Access Compliance Report Public Rights-of-Way (Pedestrian Signals)

Main Street: 17TH_ST Cross Street: HEWES_AVE Location: SW

ADA ID: SGRK211008123215 Signal Type: One Push Button-Non APS Overall Compliance: No Severity Scores: BTN 1: 35 BTN 2: N/A No BTN: N/A

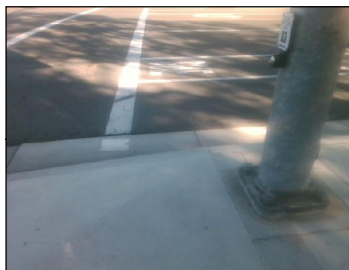
OC Std/PROW: R404.2, R404.3, MUTCD 4e.08

Possible Solutions: Replace Signal Push Button With APS Button. Remove and Replace Clear Space.
